SUBMISSIONS**REASON FOR REFERRAL TO DAU**

The proposal is for the construction and operation of a high rope adventure course within part of Bidjigal Reserve, part of Excelsior Reserve and Ted Horwood Reserve, Baulkham Hills. The proposed high rope adventure course, administration cabin and picnic shelters are shown on Attachment Nos. 3 – 6.

ATTACHMENT 4 – INDICATIVE COURSE LAYOUT

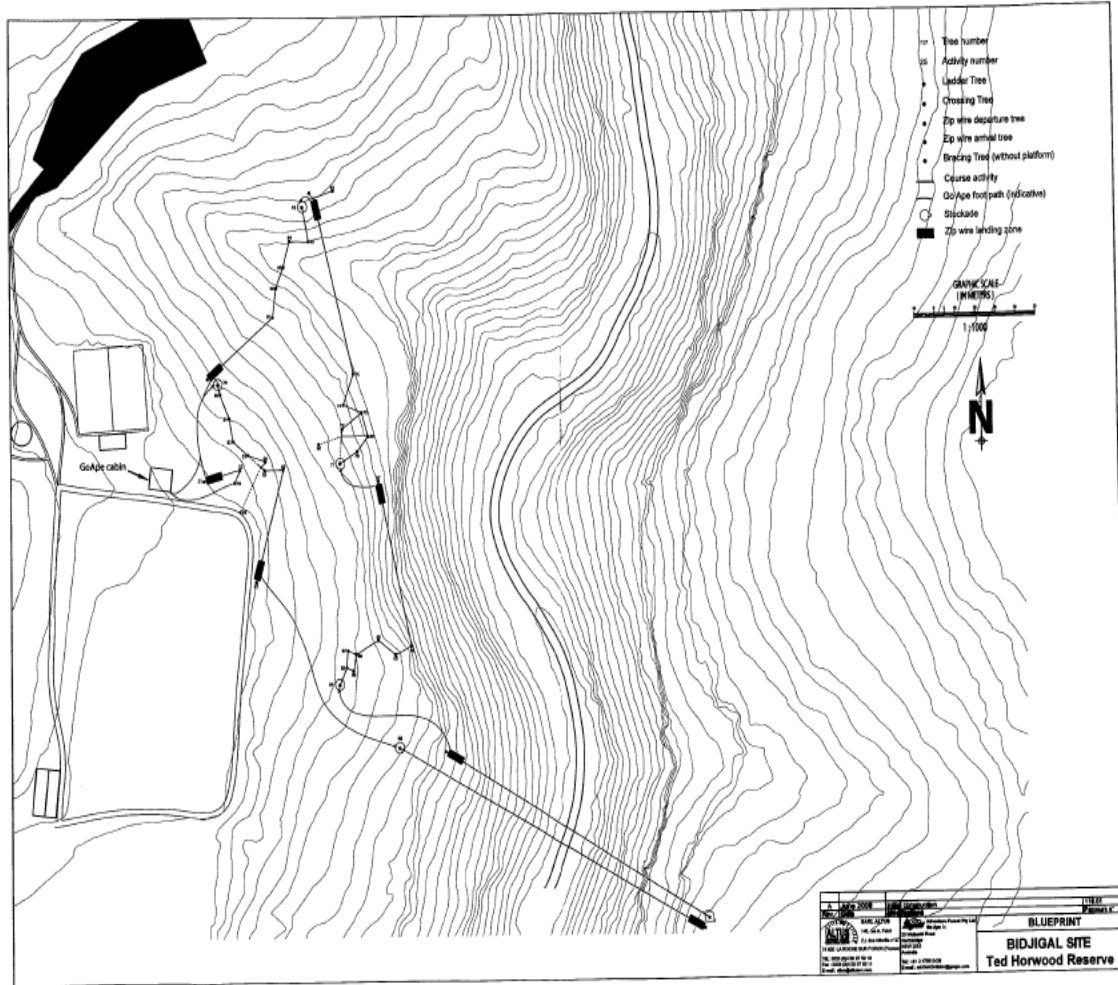
The extent and details of the wooden stockades to protect ladders, extent of clearing for zip wire landings, extent of clearing for the Reception Cabin, reception area, two small shelters and training zone (fencing required?) have not been sufficiently detailed.	The plans submitted do not indicate the full extent of the development or accurately depict its location. A complete assessment is unable to be undertaken.	This issue warrants refusal of the application.
Walking tracks - the proposal mentions tracks from the end of one area to the next one. At the Treetop Adventure Park in Ourimbah there are almost as many people walking under the course than on the course. People will follow their family or friends or just strangers to watch. It is very popular and it is very hard to keep them on the tracks. The application does not demonstrate how spectators would be restricted from moving around the course.	The issue of spectator control has not been adequately addressed in the application. The proposal indicates that spectators will not be allowed past the training area and does not provide pathways for spectators to follow the participants around the course. It is highly likely that spectators will follow/ view participants on both the eastern and western side of Darling Mills Creek causing significant impact upon the bushland.	This issue warrants refusal of the application.

Natural paths in bushland are not 1.4m wide. The proposed paths will be a blight on the Reserve. There is no guarantee that people will stay on paths. Go Ape's fact sheet on their website states "spectators are more than welcome to watch friends and family trek, swing, crawl and zip from tree to tree".	Sufficient details of the pathways including their location and justification for the width have not been provided.	This issue warrants refusal of the application.
The rehabilitation works proposed will not mitigate the damage of the bushland proposed. The proposal is contrary to the Council's current effort in bush regeneration.	Full details of the proposed regeneration or rehabilitation offsets have not been provided.	This issue warrants refusal of the application.
Rope ladders, ribbons, sacrificial battens, fences and other visual eyesores are not in keeping with the natural beauty of the Reserve.	The area concerned provides significant visual amenity for recreational users of the reserves and nearby residents. The proposed modification of vegetation is likely to reduce the aesthetic value of the reserves on both sides of the valley, and surrounding areas.	This issue warrants refusal of the application.

The submitted drawings show pathways and the timber administration cabin in different locations. The Flora and Fauna assessment does not adequately consider all issues relevant to the proposal including ancillary damage such as trampling, rubbish and weed vector transfer.

ATTACHMENT 6 – ADMINISTRATION CABIN

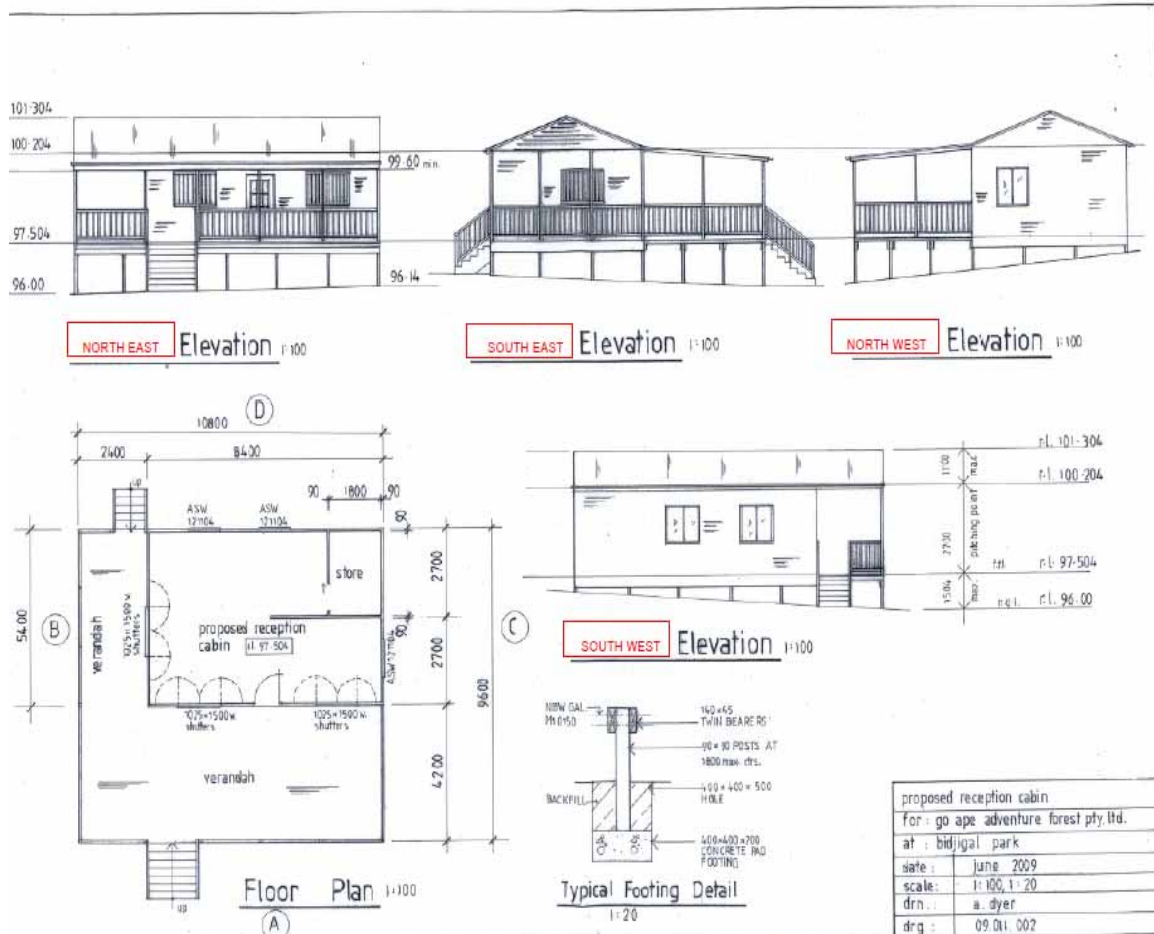
Details have not been provided showing how access for the disabled has been considered for entry into the proposed cabin, or what facilities are provided for disabled persons. No paths or ramps shown on the plan to allow access to the proposed structures.

ATTACHMENT 9 – SIGNS 2 & 3

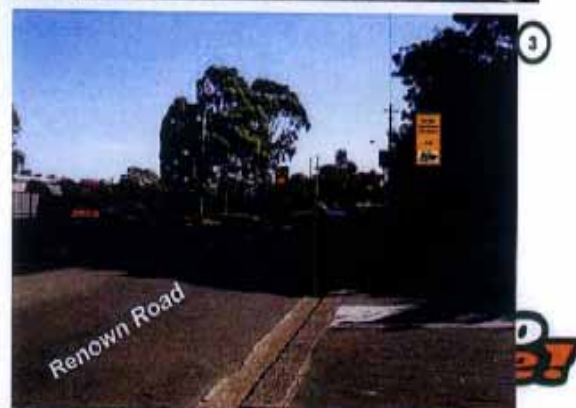
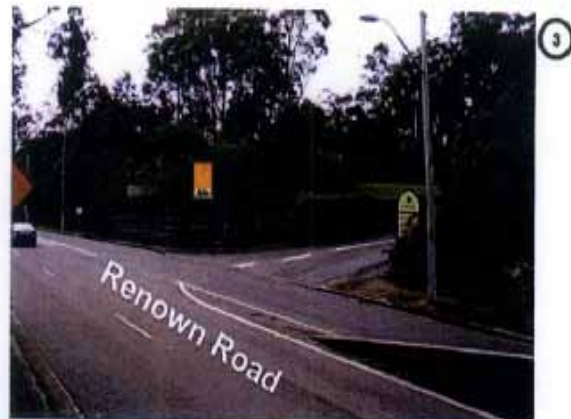
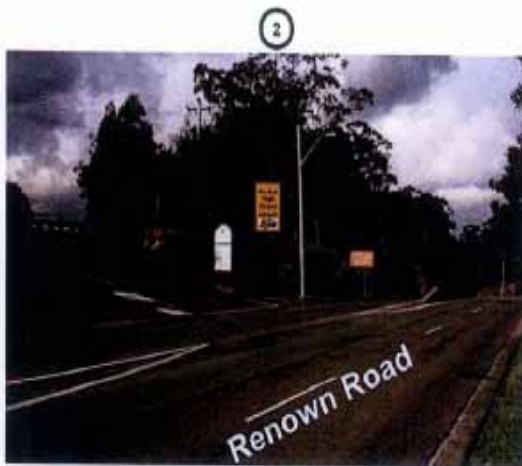
- Sign 1: Acceptable.
- Sign 2: Unacceptable. The sign is visually distracting due to its size, location and colour. It also interferes with driver interpretation of road safety signage. Furthermore the sign dwarfs Council's existing entry sign.
- Sign 3: Unacceptable. The sign encourages a dangerous right hand turn manoeuvre, it is visually obtrusive and the precise location is unclear.
- Sign 4: Acceptable, provided the location clearly demonstrated.
- Signs 5 & 6: Acceptable, provided maximum height and width is 900mm x 600mm above natural ground level. The sign is to be similar design to Council's existing entry sign at the Renown Road entry, i.e. green metal frame with a curved top. The location is required to be clearly demonstrated.
- Signs 7 – 11: Acceptable.
